The photo's below show how the combination of saturated ground followed by consistent rain create the conditions for flooding in Cropredy and closure of williamscott road, one of the main throughfares through the village.

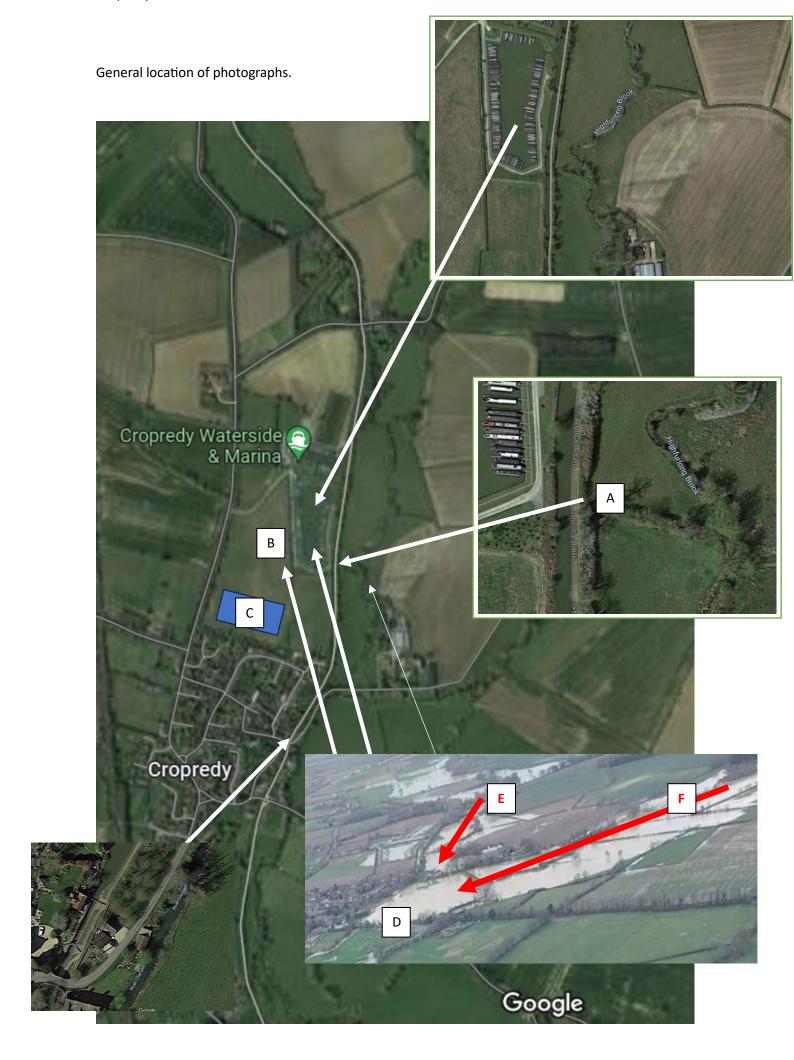
The combination of highfurlong brook being flooded from the canal spillways, then this water course joining with the river Cherwell (also flooded) creates the flood at Williamscott road. Any additional water being added to the canal from the Obsidian development (via the marina) can only increase the flooding of this road and having the potential to flood the businesses along the river behind the village shop.

The obsidian development is located directly on top of the main clay basin and as such water cannot infiltrate into the ground so will require pools (suds) to store the water run off from the development, then being discharging into the marina (there is no other means of egress for this water.)

Discharging water into already flooded water courses can only be considered foolhardy and will create flooding within the village outside of the development. Moving a flood to another populated area must be prohibited.
